OPTIONAL SERVICE BULLETIN NO. DAC1-24-05 REV. 2
SUPERSEDES DAC1-24-05 REV. 1

I.5 Subject

ATA code: 2400.

Diamond Aircraft Industries
OPTIONAL SERVICE BULLETIN
Model DA 20-C1

Figure 1

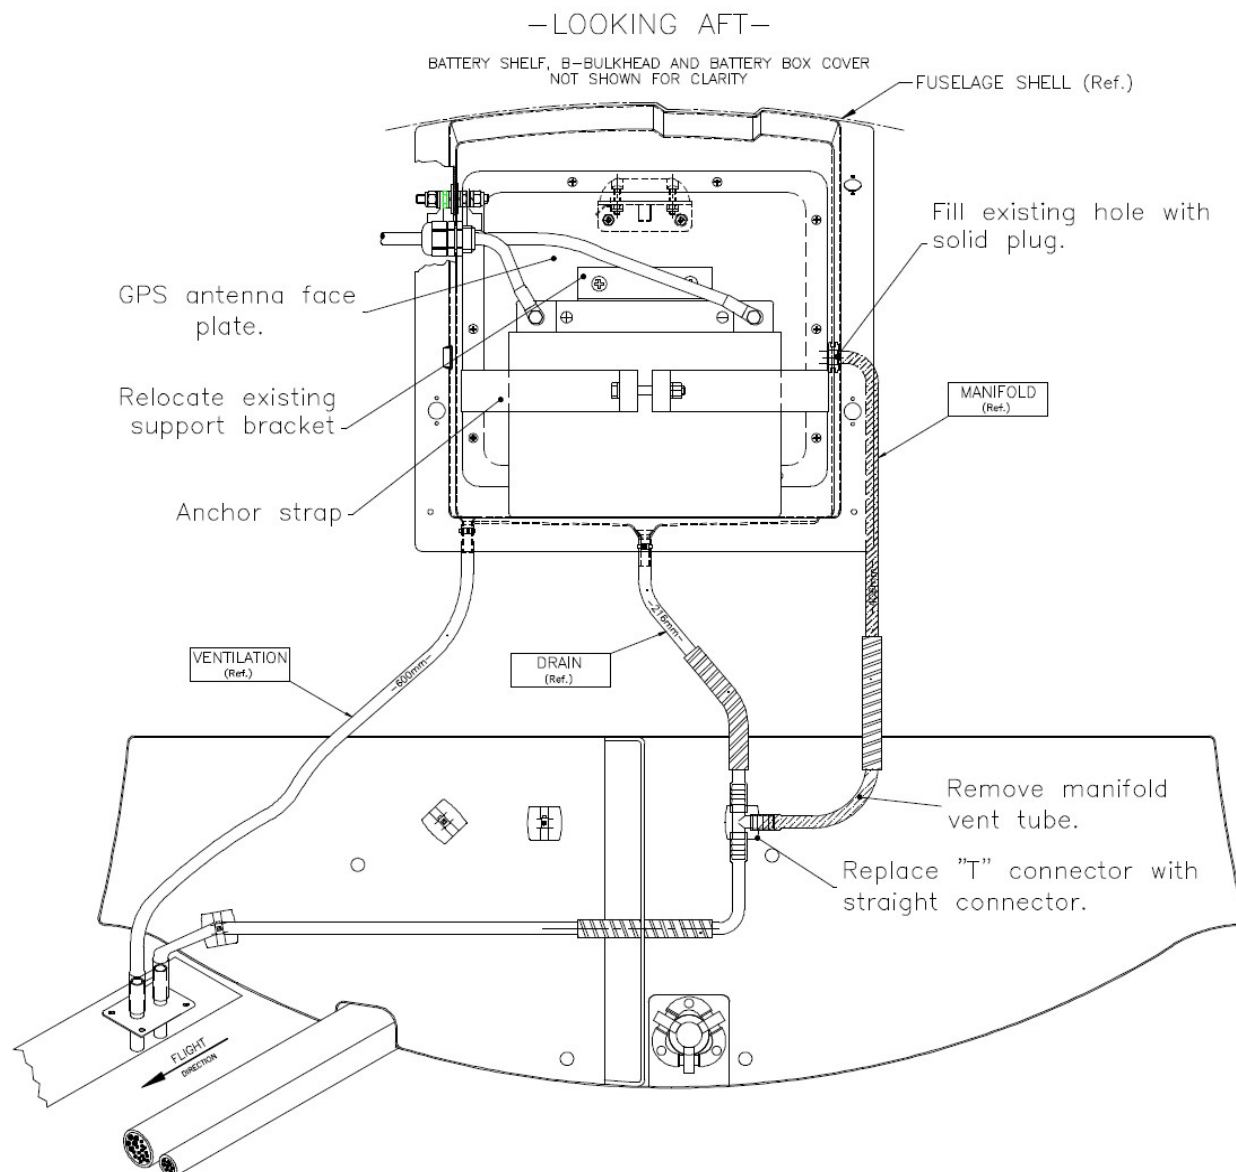
1. Remove the Yuasa battery. Refer to AMM Section 24-31.
2. Remove the baggage floor. Remove the battery manifold overboard drain tube and replace the "T" tube connector (ty-wrapped to half-ring bulkhead) with the straight connector (item 4). Plug hole in battery compartment with plug (item 5). Refer to Figure 1.

3. Replace the existing anchor strap with the new one (item 9) using the existing bolts.
4. Place B&C (item 10) or Odyssey (item 10a) battery on the battery shelf and push it all the way aft. The terminals point toward the front of aircraft.
5. Using the existing support bracket removed in the step 1, locate two new mounting holes on the GPS antenna face plate.
